UNITED STATES PATENT AND TRADEMARK OFFICE

10/099,775

Office Action Summary	Application No. 10/099,775	Applicant(s) KLING, JEAN-CHRISTOPHE JACQUES	
	Examiner HUNTER M. DREIDAME	Art Unit 3633

DETAILED ACTION

Annotated figure taken from de Chicchis, Fig. 1

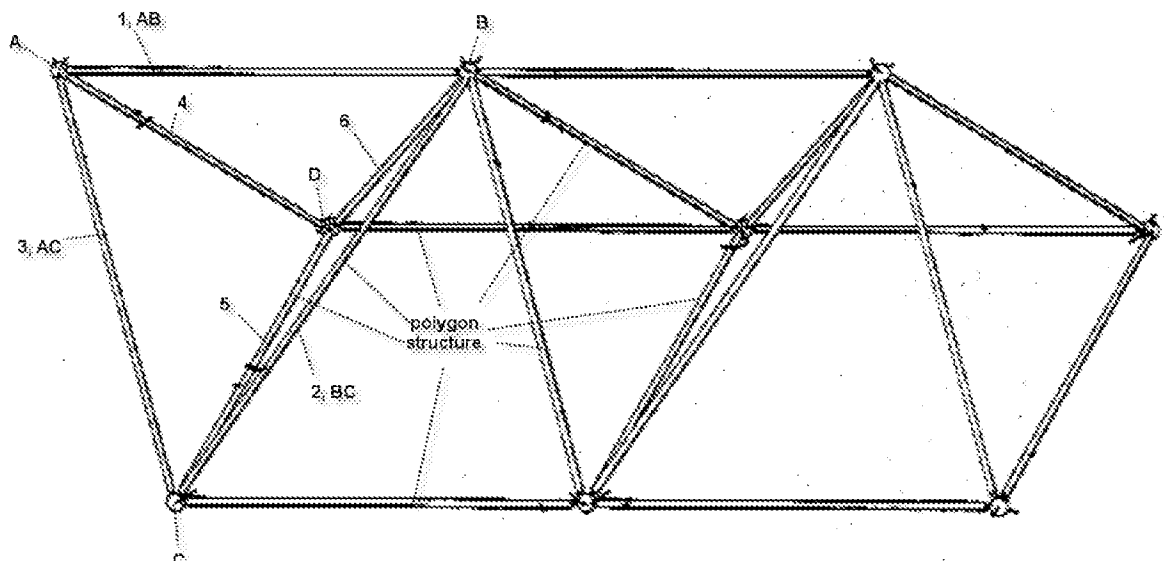
As to claim 1, de Chicchis et al. disclose an architectural system (Fig. 1) comprising a triangular base (1, 2, 3, annotated figure) comprising first (1, annotated figure), second (2, annotated figure) and third (3, annotated figure) complete struts substantially aligned along first, second, and third axes (AB, BC, and AC, annotated figure) respectively, the axes all contained within a base plane, the first and third axes forming a first base angle (CAB, annotated figure), the first and second axes forming a second base angle (ABC, annotated figure), the second and third axes forming a third acute base angle (BCA, annotated figure), more than one of the struts each comprising at least two rigid pieces (10, 20, 22, Fig. 2) able to move apart so as to produce a strut elongation; a first node (A, annotated figure) engaging the first and third complete struts, the first node large enough to maintain the first base angle, the first base angle

consisting of a first positive value about equal to $(j \times 20.9^\circ + k \times 31.7^\circ + m \times 36^\circ + n \times 37.4^\circ)$, where j , k , m , and n are each an integer less than three (shown in annotated figure); a second node (B, annotated figure) engaging the first and second complete struts, the second node large enough to maintain the second base angle, the second base angle consisting of a second positive value about equal to $(q \times 20.9^\circ + r \times 31.7^\circ + s \times 36^\circ + t \times 37.4^\circ)$, where q , r , s , and t are each an integer less than three (shown in annotated figure); a third node (C, annotated figure) engaging the second and third complete struts, the third node C large enough to maintain the third base angle at a third positive value less than 60° (shown in annotated figure); and an extension (4, 5, or 6, annotated figure) engaging the triangular base and comprising a fourth complete strut substantially aligned along a fourth axis that forms a substantially acute angle $> 3^\circ$ with the base plane (shown in annotated figure).

As to claim 2, de Chicchis et al. disclose the architectural system of claim 1 in which the fourth axis (4, annotated figure) forms an angle DAB with the first axis that is substantially equal to a reference angle selected from a group consisting of 13.3° , 15.5° , 20.9° , 22.2° , 31.7° , 5.3° , 36° , 37.4° , 37.8° , 41.8° , 44.5° , 45° , 54.7° , 58.3° , 60° , 63.4° , 65.9° , 69.1° , 70.5° , 72° , 75.5° , 76.7° , 79.2° , 82.2° , 90° , 97.8° , 100.8° , 103.3° , 104.5° , 108° , 109.5° , 110.9° , 114.1° , 116.6° , 120° , 121.7° , 125.3° , 135° , 135.5° , 138.2° , 142.2° , 142.6° , 144° , 144.7° , 148.3° , 155.9° , 157.8° , 159.1° , 164.5° , and 166.7° (shown in annotated figure).

substantially equal to a reference angle selected from a group consisting of 13.3°, 15.5°, 20.9°, 22.2°, 31.7°, 35.3°, 36°, 37.4°, 37.8°, 41.80°, 44.5°, 45°, 54.7°, 58.3°, 60°, 63.4°, 65.9°, 69.1°, 70.5°, 72°, 75.5°, 76.7°, 79.2°, 82.2°, 90°, 97.8°, 100.8°, 103.3°, 104.5°, 108°, 109.5°, 110.9°, 114.1°, 116.6°, 120°, 121.7°, 125.3°, 135°, 135.5°, 138.2°, 142.2°, 142.6°, 144°, 144.7°, 148.3°, 155.9°, 157.8°, 159.1°, 164.5°, and 166.7° (shown in annotated figure).

As to claim 4, de Chicchis et al. disclose the architectural system of claim 1 in which the fourth axis (6, annotated figure) forms a fourth angle with another of the axes that is substantially equal to a reference angle selected from a group consisting of 13.3°, 15.5°, 20.9°, 22.2°, 31.7°, 35.3°, 36°, 37.4°, 37.8°, 41.8°, 44.5°, 45°, 54.7°, 58.3°, 60°, 63.4°, 65.9°, 69.1°, 70.5°, 72°, 75.5°, 76.7°, 79.2°, 82.2°, 90°, 97.8°, 100.8°, 103.3°, 104.5°, 108°, 109.5°, 110.9°, 114.1°, 116.6°, 120°, 121.7°, 125.3°, 135°, 135.5°, 138.2°, 142.2°, 142.6°, 144°, 144.7°, 148.3°, 155.9°, 157.8°, 159.1°, 164.5° and 166.7° (shown in annotated figure).

As to claim 6, de Chicchis et al. disclose the architectural system of claim 4 further comprising a polygon structure (7, annotated figure) coupled to the fourth complete strut (4, annotated figure), the polygon structure having N sides each occupied by a respective complete strut, the third axis containing one of the N sides, the

fourth axis containing another of the N sides wherein the fourth complete strut forms a portion of the polygon structure (shown in annotated figure).

As to claim 7, de Chicchis et al. disclose the architectural system of claim 4 in which $j=0$ (shown in annotated figure).

As to claim 8, de Chicchis et al. disclose the architectural system of claim 4 in which j and q are both even (shown in annotated figure).

As to claim 9, de Chicchis et al. disclose the architectural system of claim 4 in which $j=1$ (shown in annotated figure).

As to claim 14, de Chicchis et al. disclose the architectural system of claim 4 in which $m=0$ (shown in annotated figure).

As to claim 15, de Chicchis et al. disclose the architectural system of claim 1 in which $m=0$ (shown in annotated figure).

As to claim 16, de Chicchis et al. disclose the architectural system of claim 1 in which j is not equal to q (shown in annotated figure).

As to claim 17, de Chicchis et al. disclose the architectural system of claim 1 in which q is less than 2 (shown in annotated figure).

As to claim 18, de Chicchis et al. disclose the architectural system of claim 1 in which $k=0$ (shown in annotated figure).

As to claim 19, de Chicchis et al. disclose the architectural system of claim 1 in which k and r are both even (shown in annotated figure).

As to claim 20, de Chicchis et al. disclose the architectural system of claim 1 in which k is not equal to 1 (shown in annotated figure).

As to claim 21, de Chicchis et al. disclose the architectural system of claim 1 in which $n = t$ (shown in annotated figure).

As to claim 22, de Chicchis et al. disclose the architectural system of claim 1 in which $j=0$ (shown in annotated figure).

As to claim 23, de Chicchis et al. disclose the architectural system of claim 1 in which j and q are both even (shown in annotated figure).

As to claim 24, de Chicchis et al. disclose the architectural system of claim 1 in which $j=1$ (shown in annotated figure).
